BALTIMORE COUNTY PUBLIC SCHOOLS

ADDENDUM NUMBER _1_

BID NAME: NEW SCHOOL CONSTRUCTION LANSDOWNE ELEMENTARY
SCHOOL/DEMOLITION OF LANSDOWNE ELEMENTARY
SCHOOL__

BID NUMBER: **MBU-516-17**

1

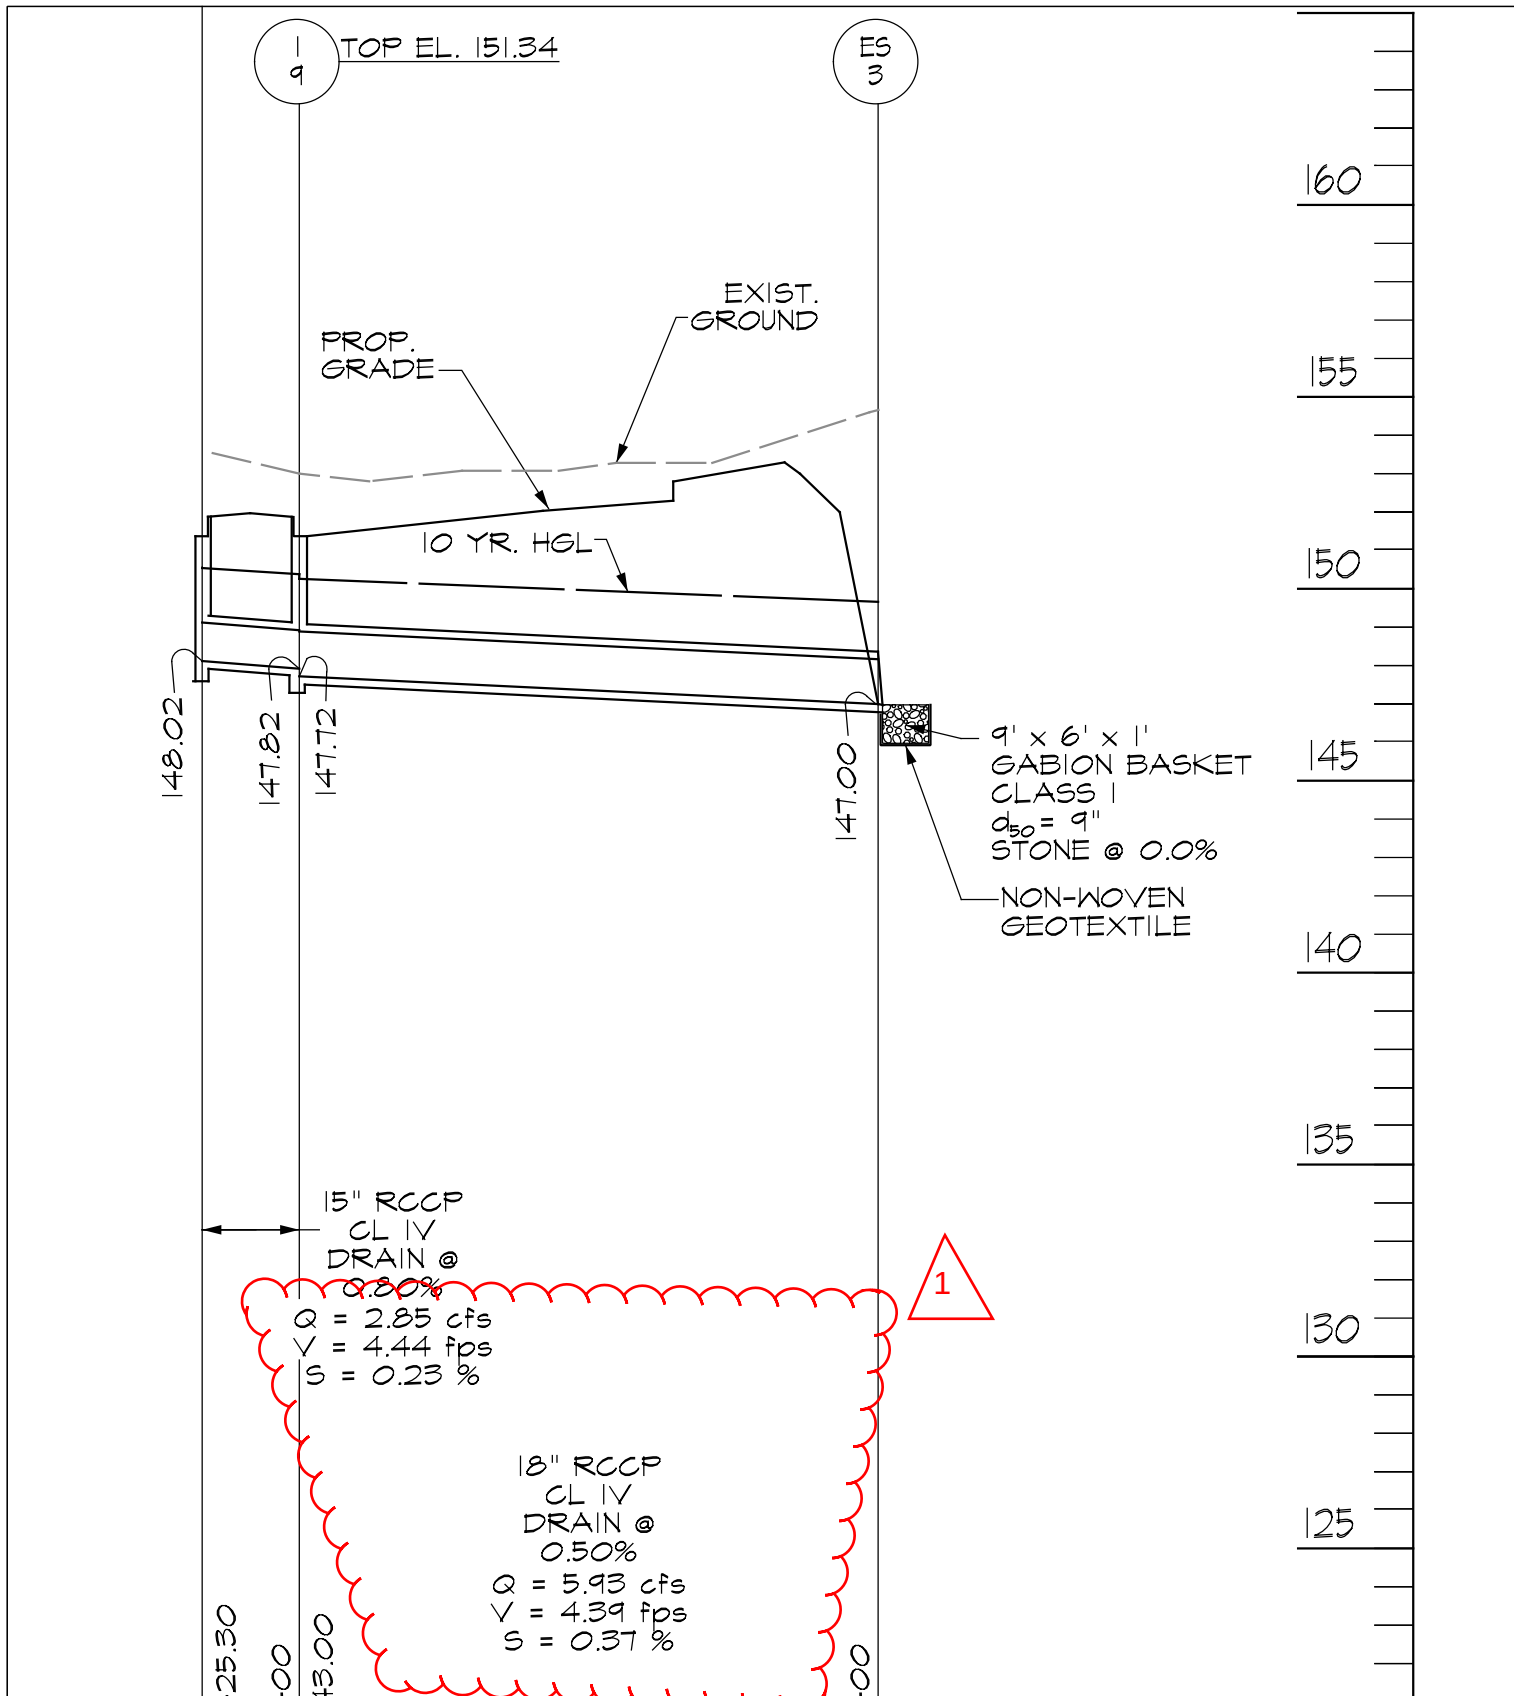
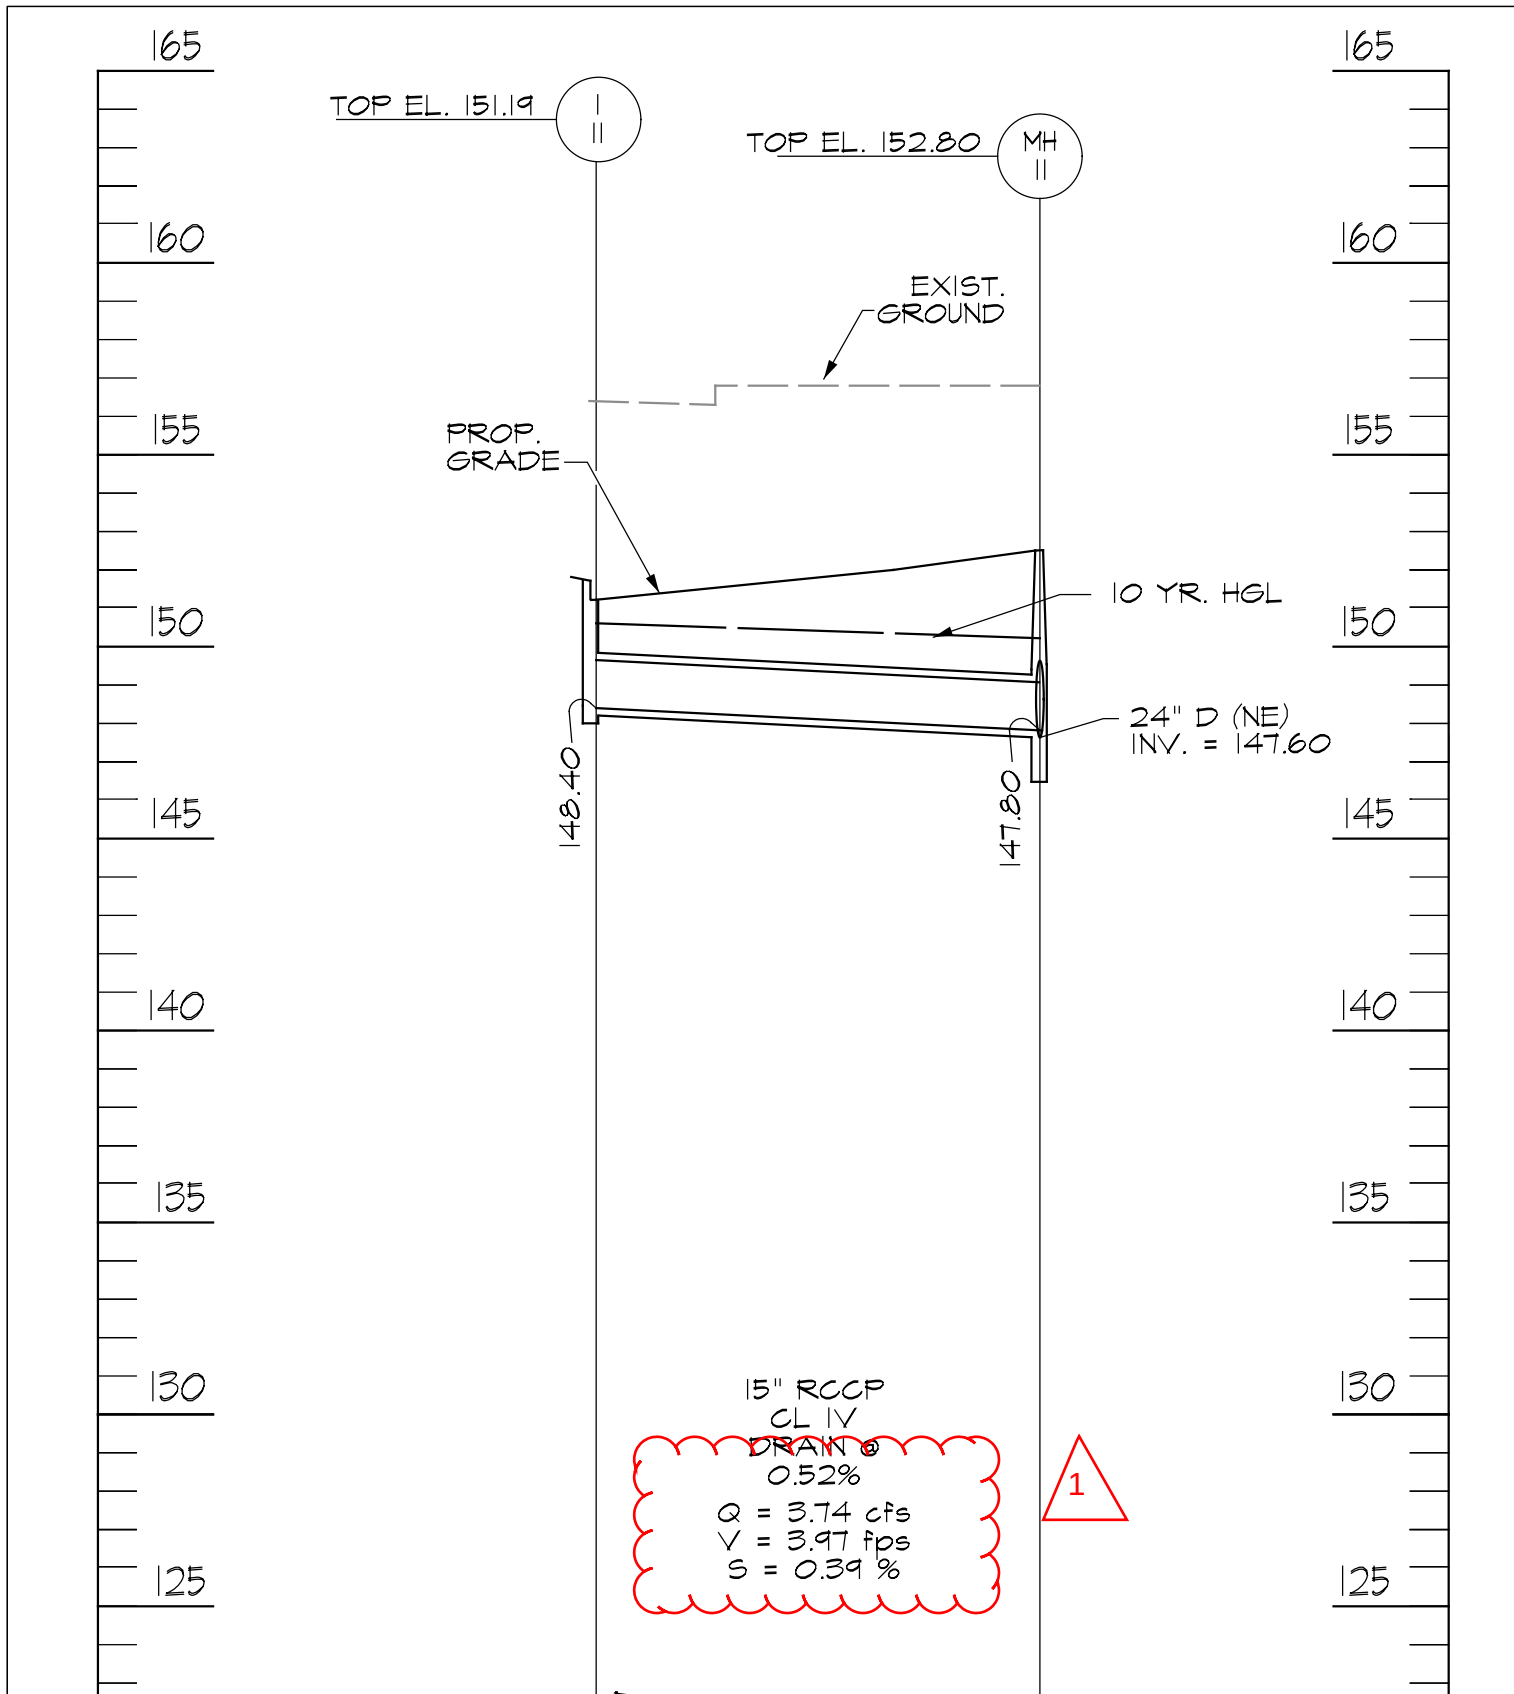
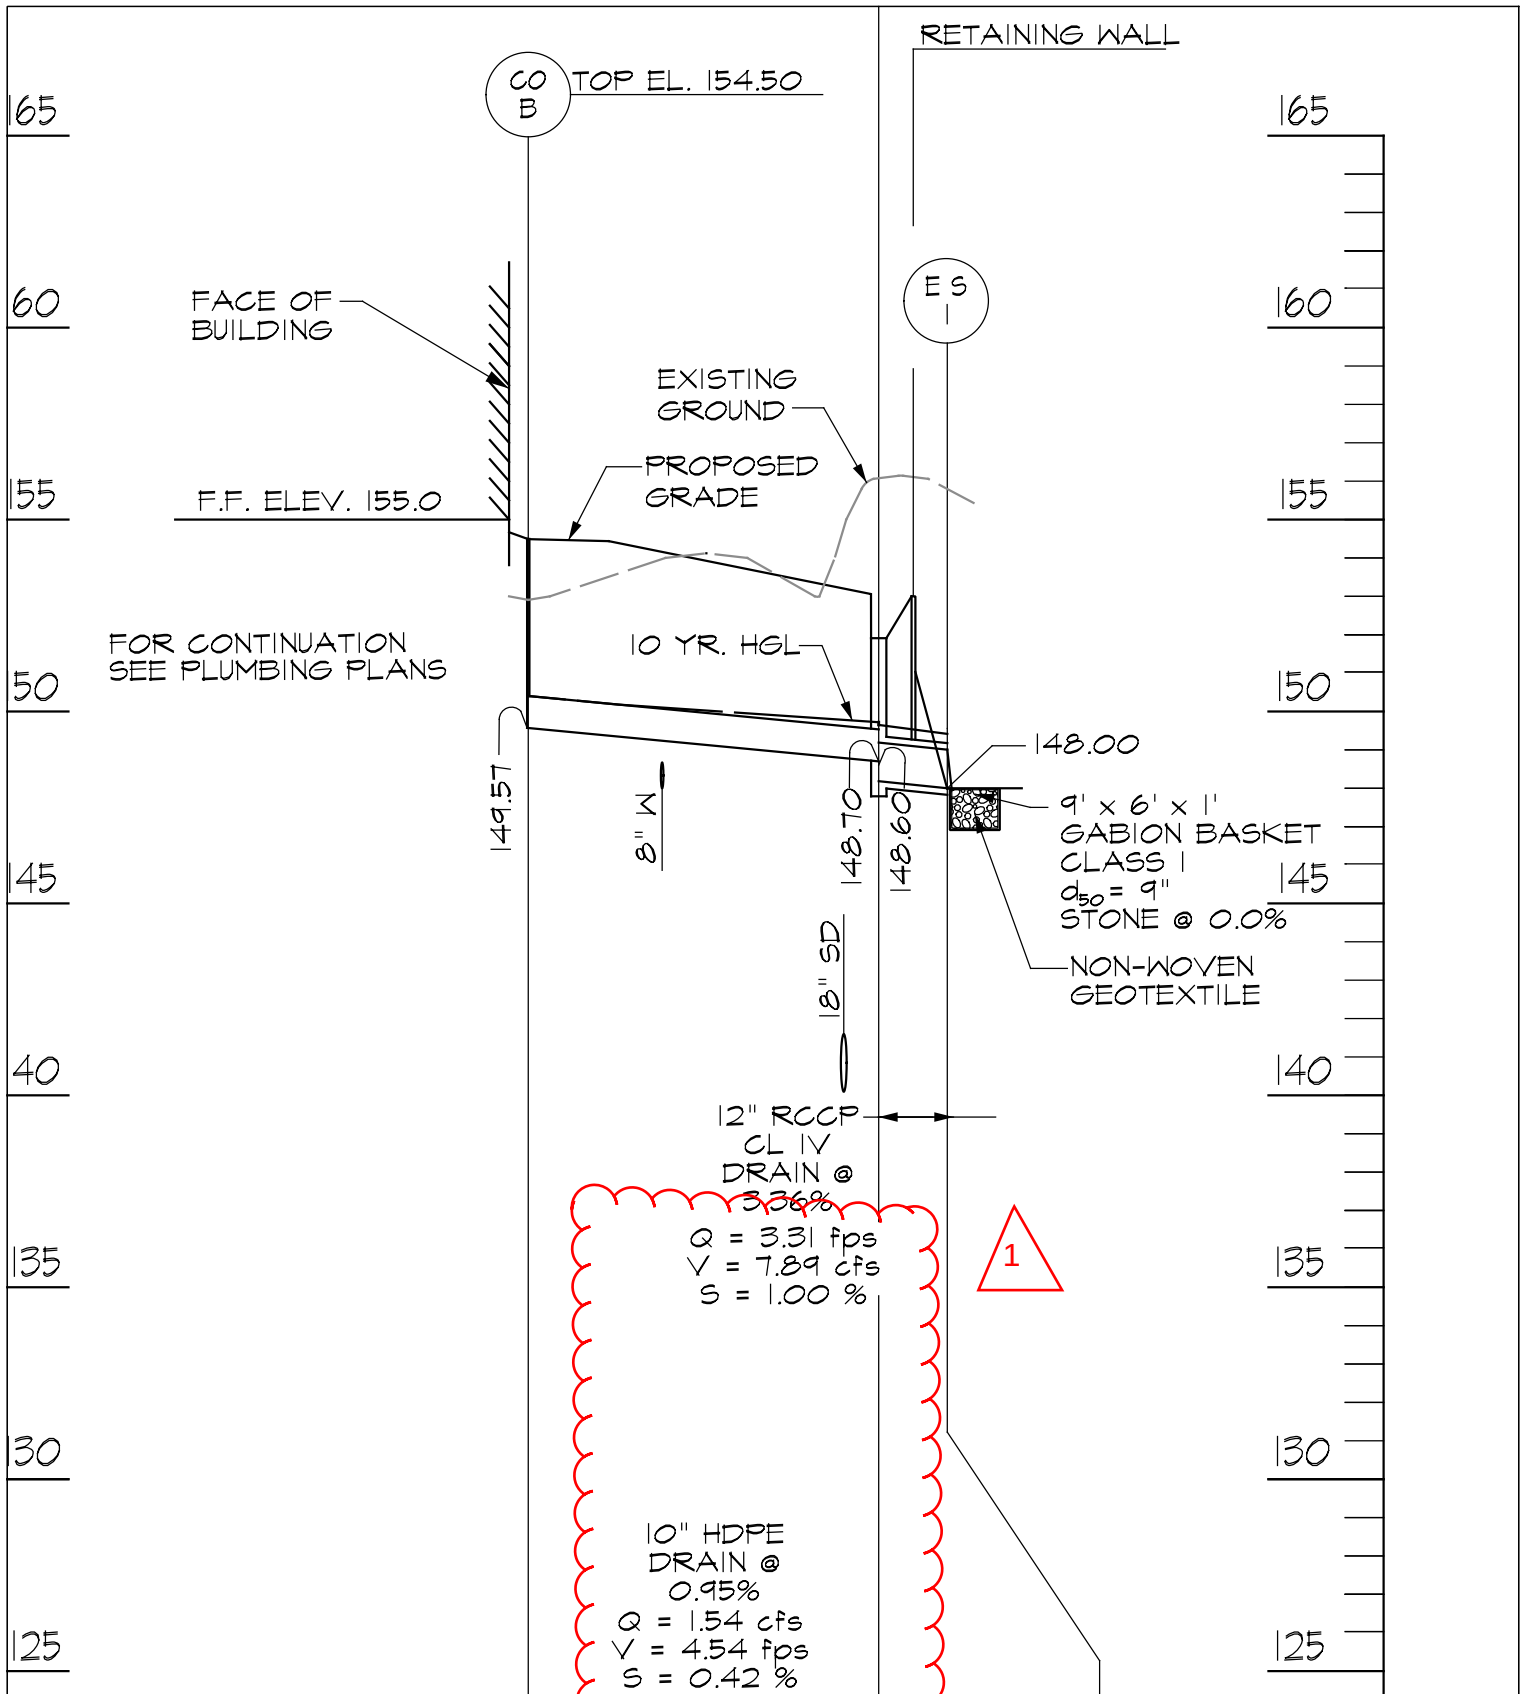
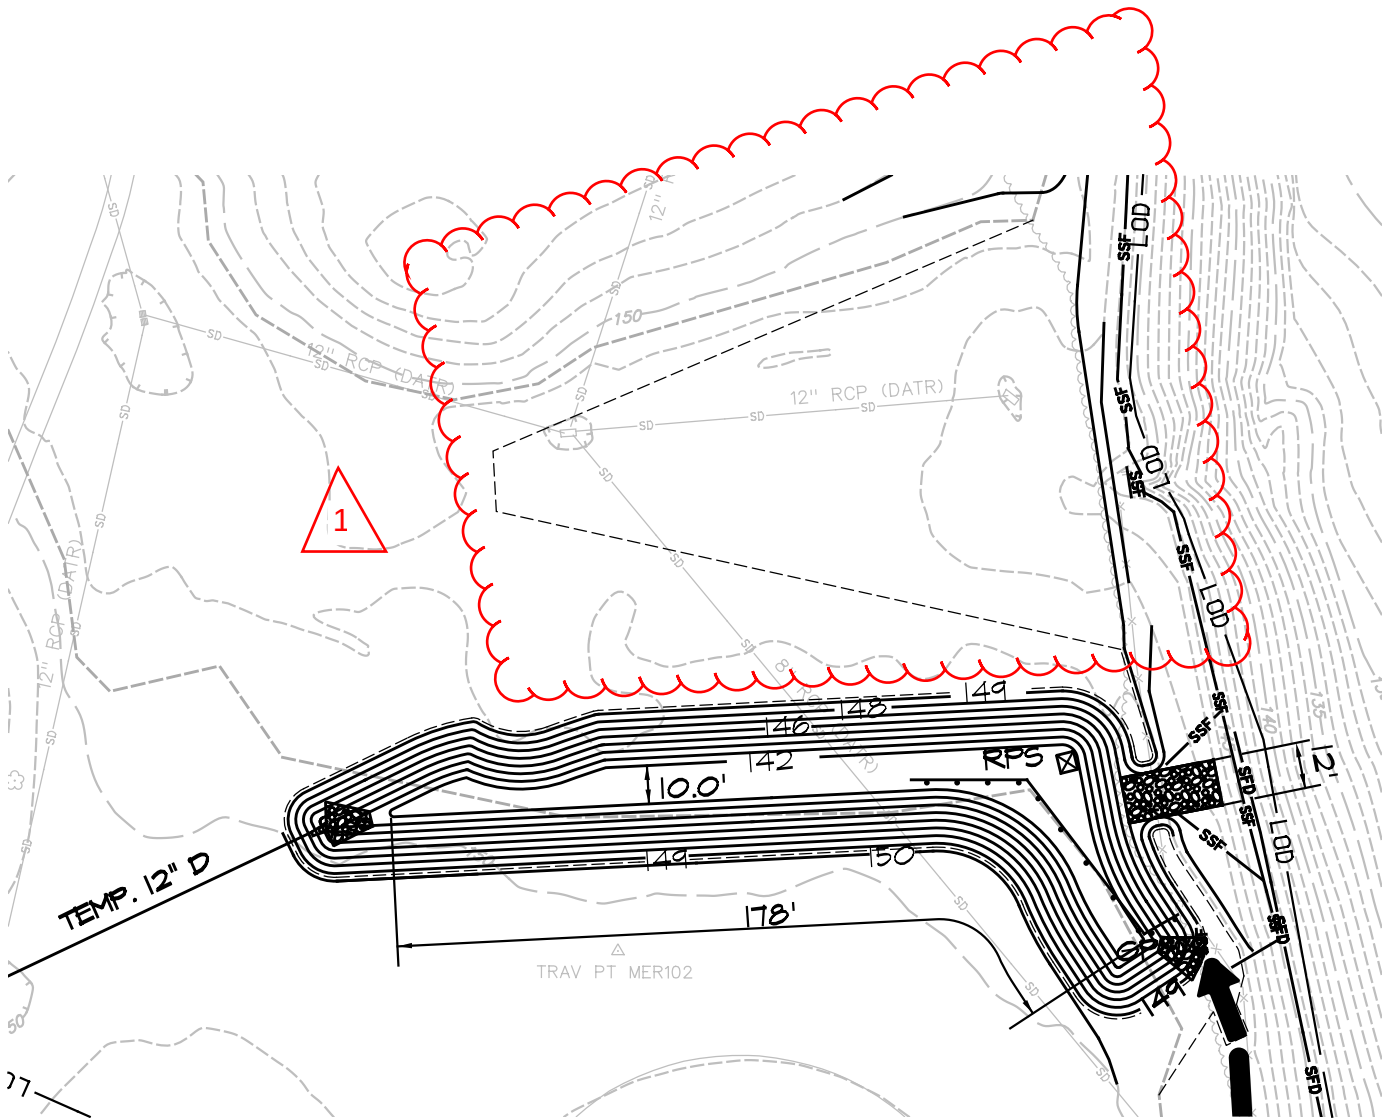
- 3.14. SHEET C-4.6, UTILITY PROFILES
REVISE: Storm Drain Profiles as indicated in attached sketch SK-C-13 – 13I.
- 3.15. SHEET C-5.1, STORM DRAIN DRAINAGE AREA MAP
REVISE: Storm Drain Design Data chart as indicated in attached sketch SK-C-14.

SK- C -15

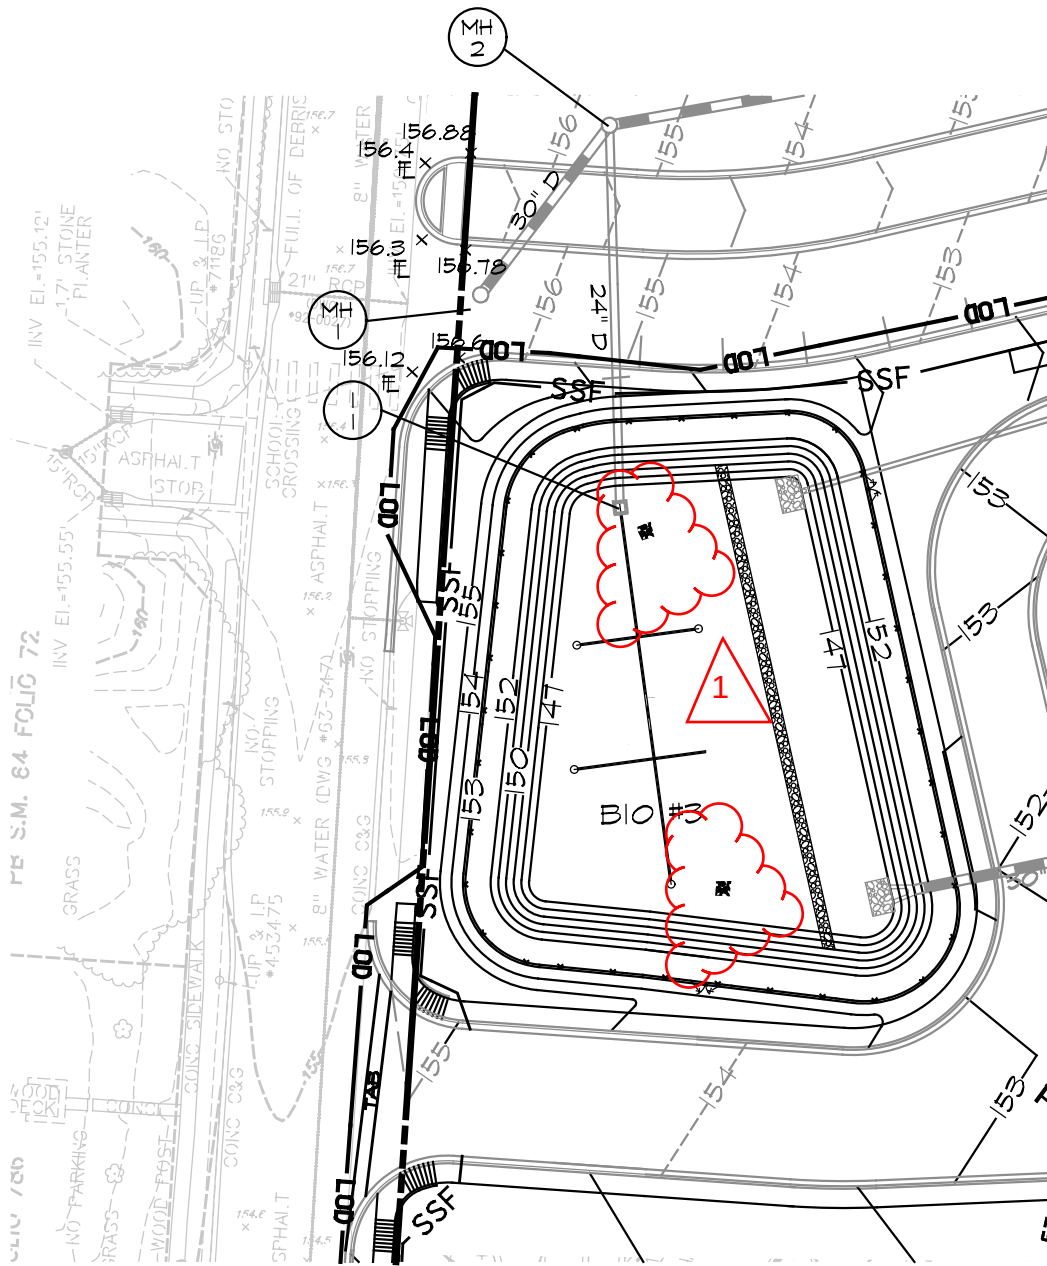
- 3.16. SHEET C-6.3, SEDIMENT AND EROSION CONTROL TRAP NO. 1 INSET PLAN
REVISE: Sediment Trap-1 Phase 1 Installation as indicated in attached sketch SK-C-15.
